**ADDENDA NO. 3**

**Moorpark College Parking Structure & Police Station**

Project No. 10-555

Date: 08.22.2012

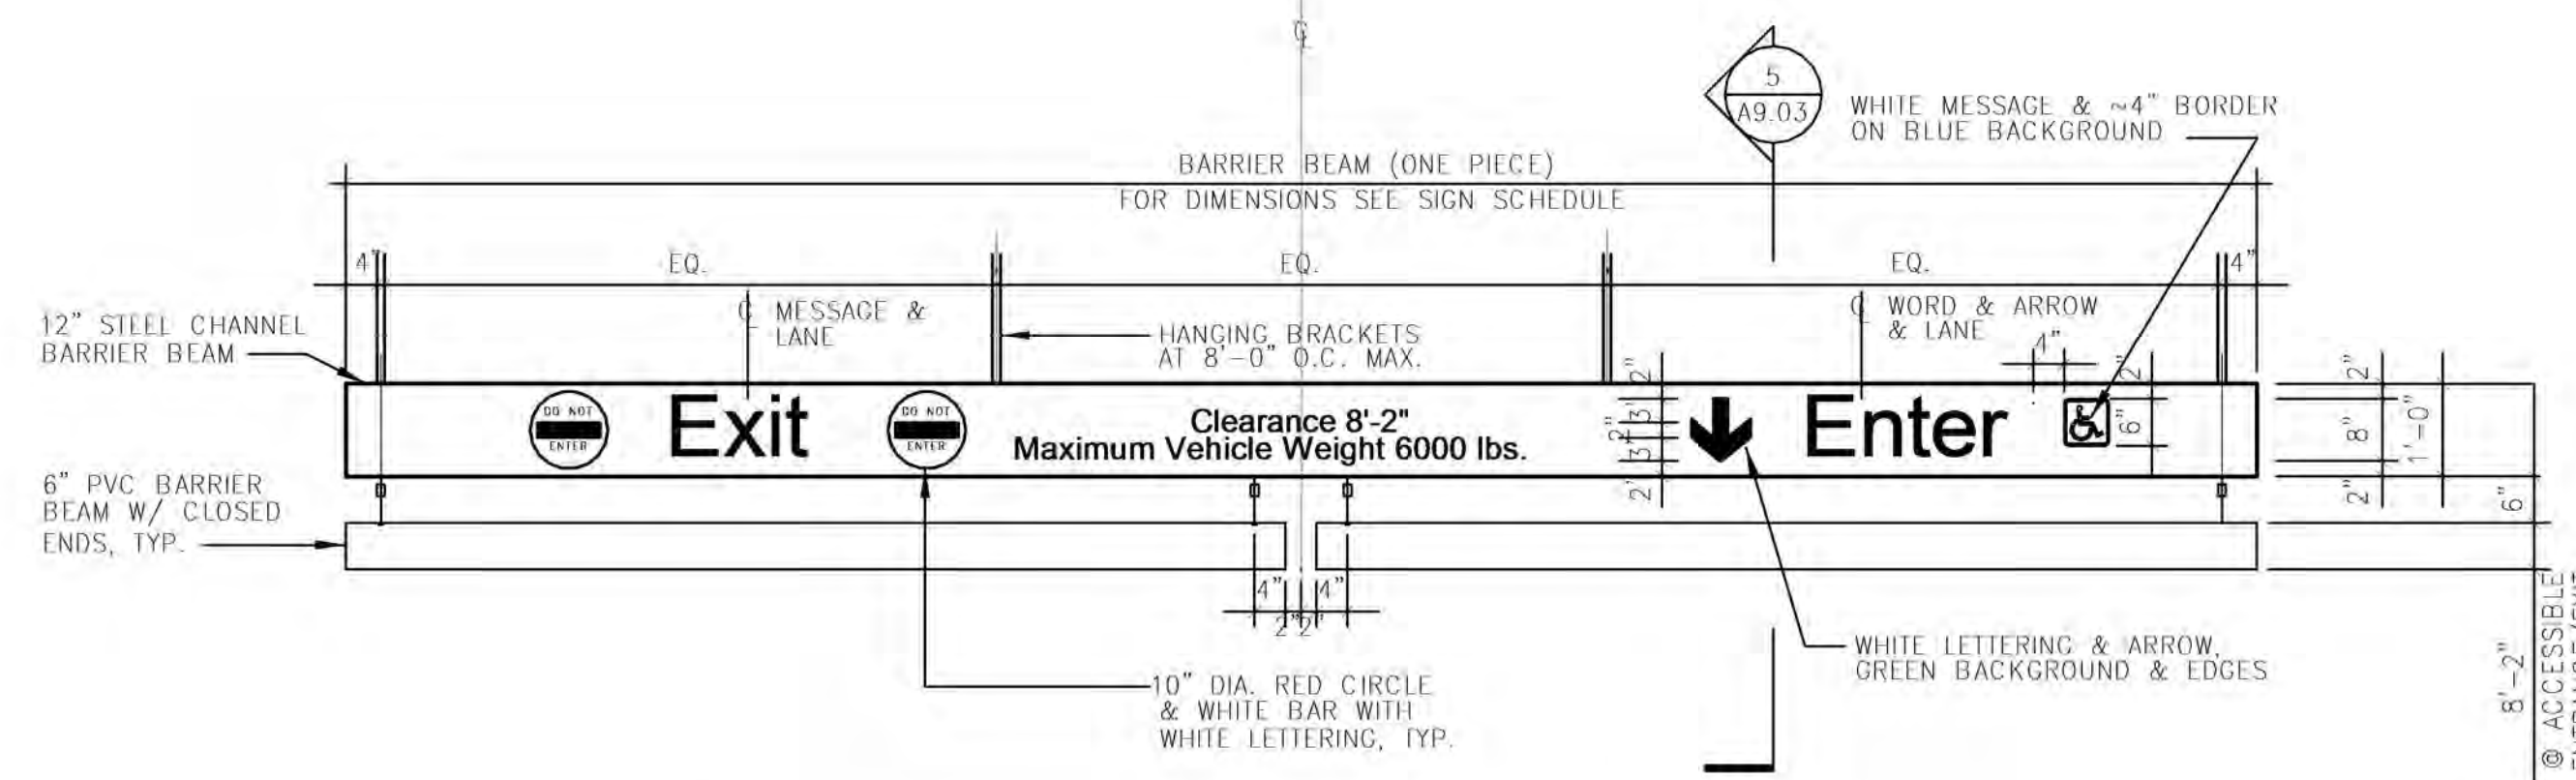
Q13- Is vapor barrier/sand (reference page 22 of soils report) required? It is called out in the soils report but not indicated in the plans and there is no moisture sensitive flooring at B1 level. Please clarify.

A13- See specification book, Section 02225, item B.8

Sheet Title  
**SIGNAGE & GRAPHICS SCHEDULE**  
Sheet No.  
**A9.01**

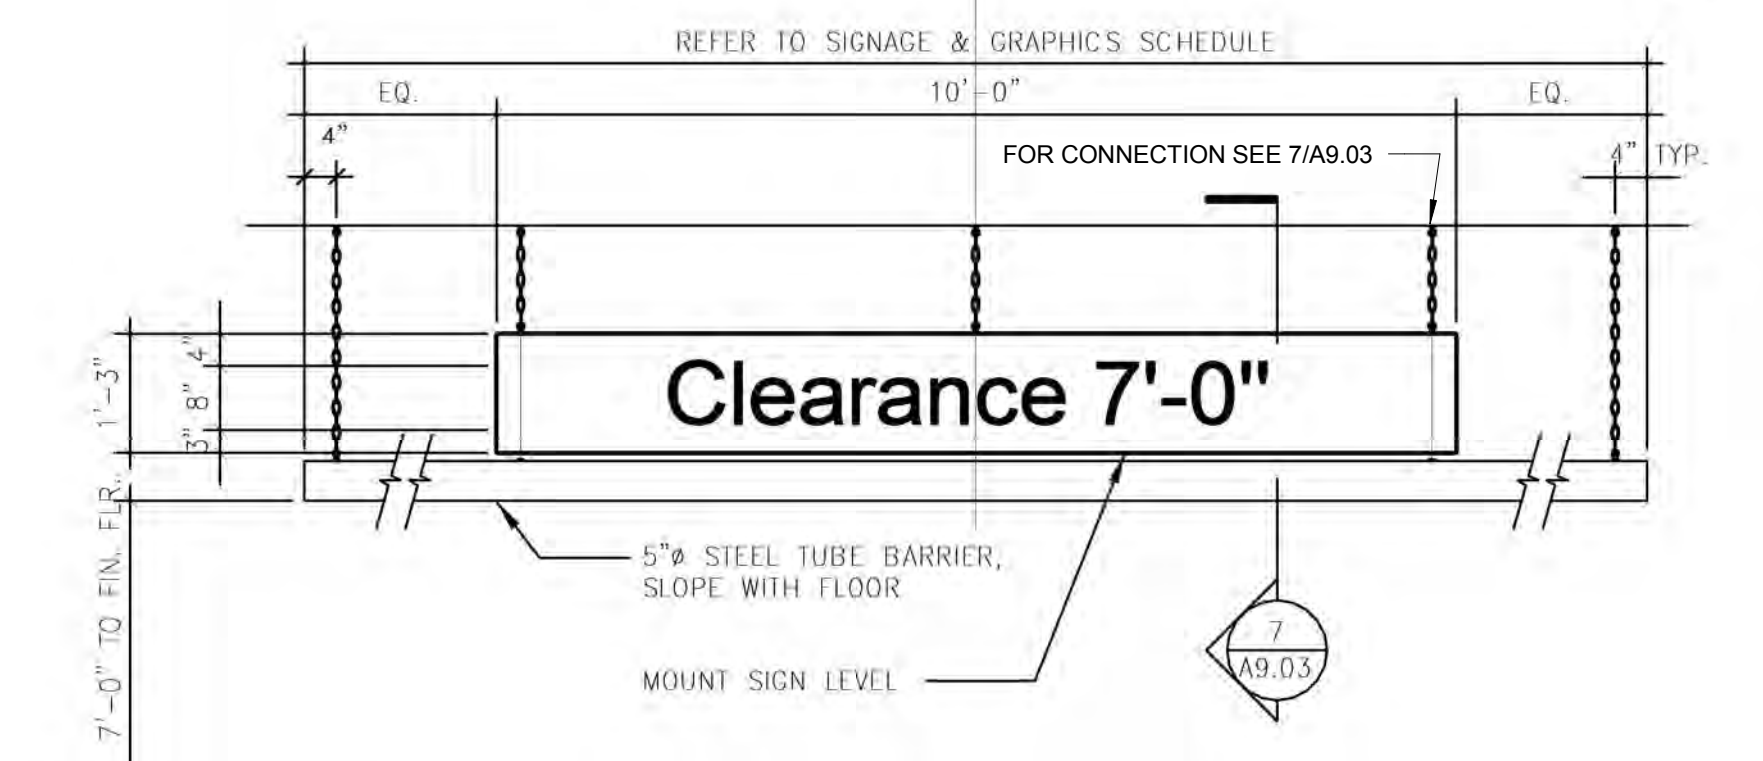
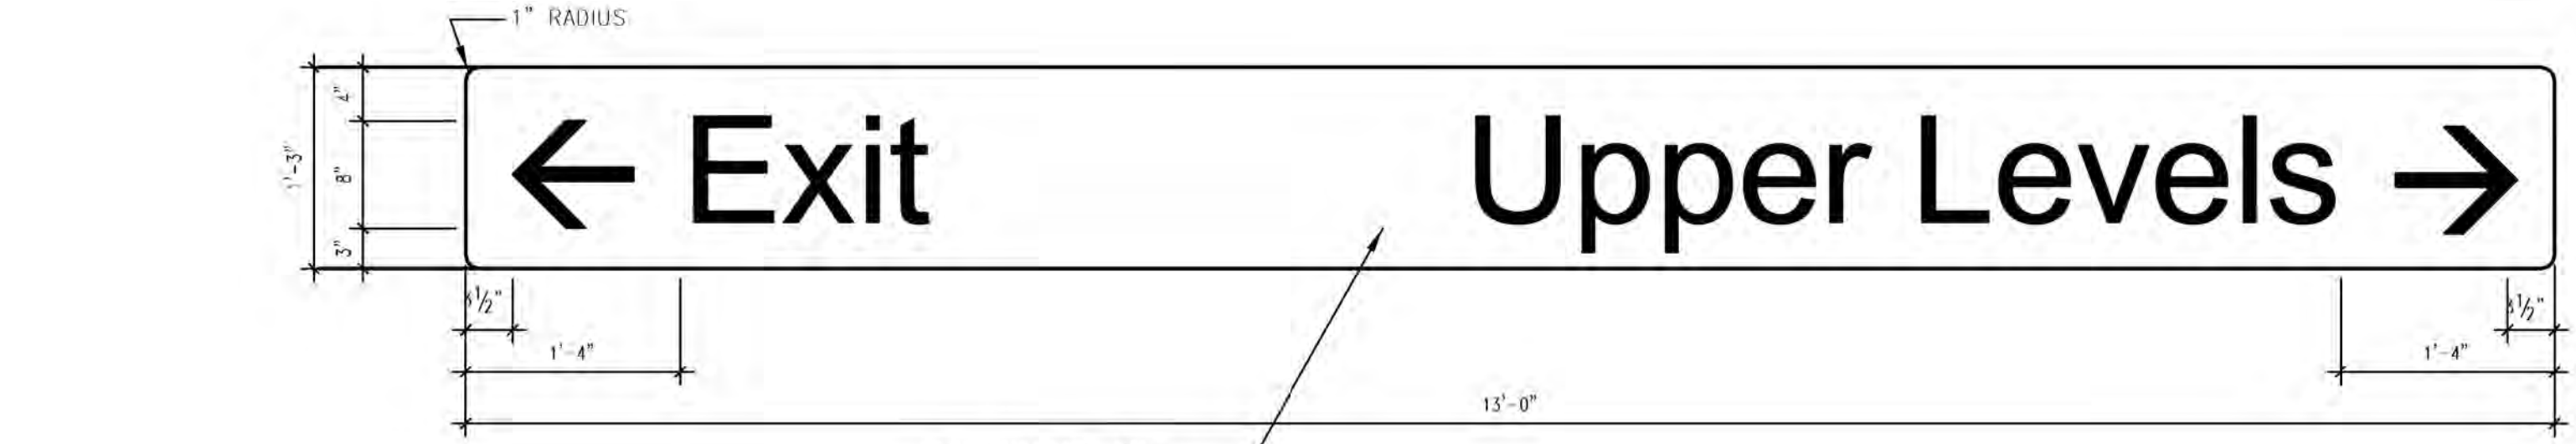
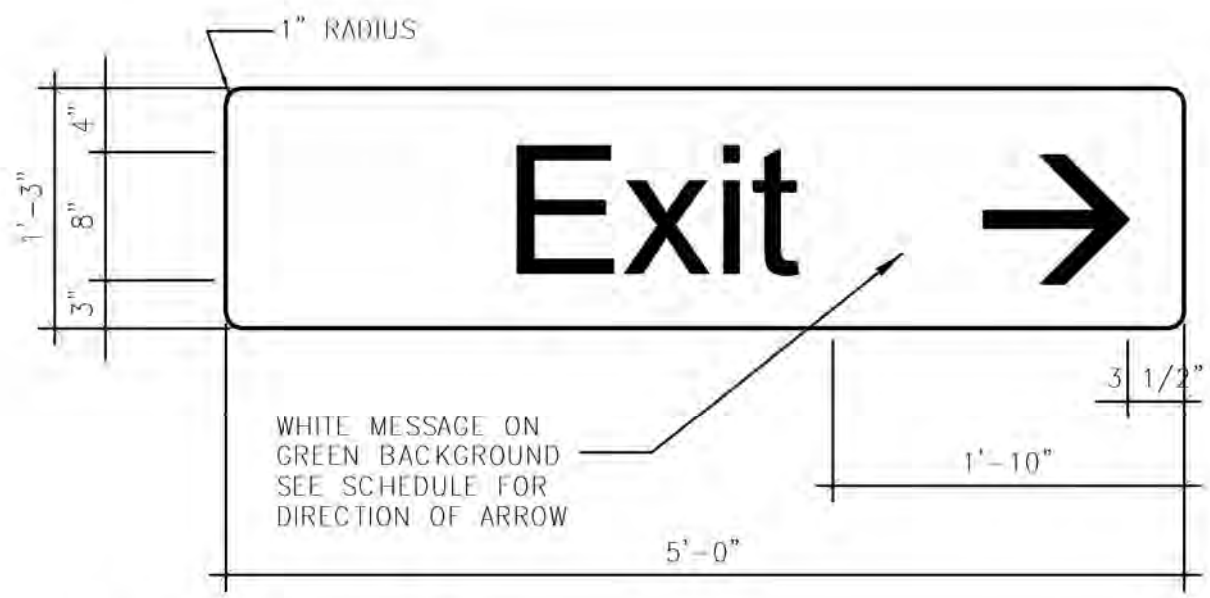
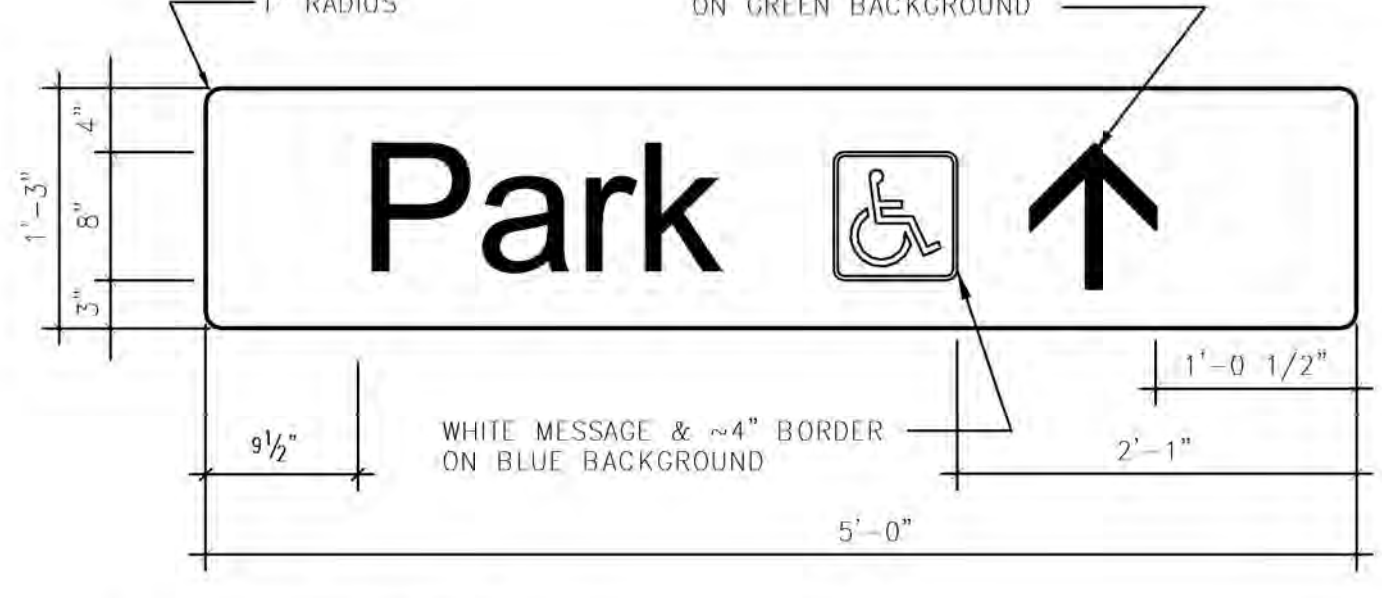
Revised and added information to sheet A9.01

Q1- Sign Type 59 is called for on two of the Plan Pages. ST 59 is not listed, please provide requirements and information.

Q4- St S-57 - the plan pages give no description. Please provide a description of this sign.

A1- See attached PDF (A9.01) for clarification.

A4- Information Provided (See attached A9.01)
